FIELD INSPECTION

Project Name:	Mountain Valley Pipeline	Inspector:	Matthew Grant
Inspection Date:	Tuesday, January 14, 2020	Project Contact:	Brian Clauto
Spread: Montgomery County MP 229-231 AR-MN 270.01 ATWS 701	Spread H	Weather (Wet/Dry/Rain):	Wet

FIELD INSPECTION PHOTO LOG

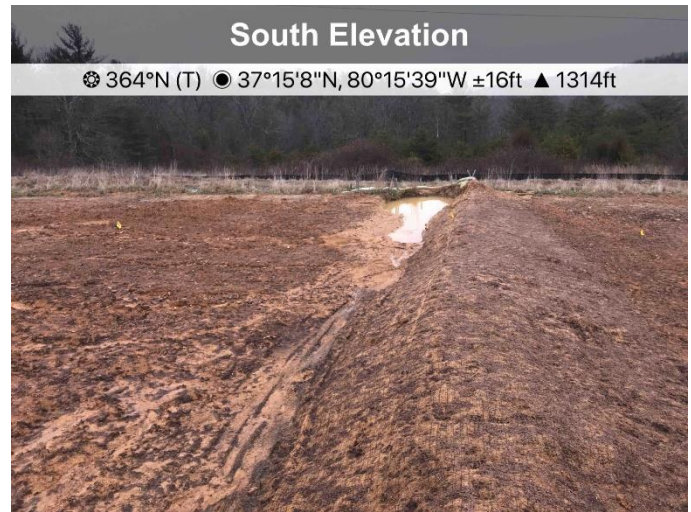
- Inspected designated streams and wetlands included S-MM 11, S-F15, S-16A &B, S-C33, S-C36, S-MM31, S-C25, S-C24, S-C21, S-OO11.
- ECD's were in place and functioning at the designated crossings.
- St 12186+00 waterbar flow path requires maintenance and approximately MP 230.6 – 230.8 requires additional stabilization.

- Fig. 1. Approximately MP 230.6 – 230.8 requires additional stabilization.

- Fig. 2. St 12186+00 waterbar flow path requires maintenance

- Fig. 3. Designated crossing S-C21, ECD's are in place and functioning.

- Fig. 4. St12116+00 permanent style waterbar has been installed and is functioning.

Recommend Corrective Action: Maintain all controls per the approved plan.
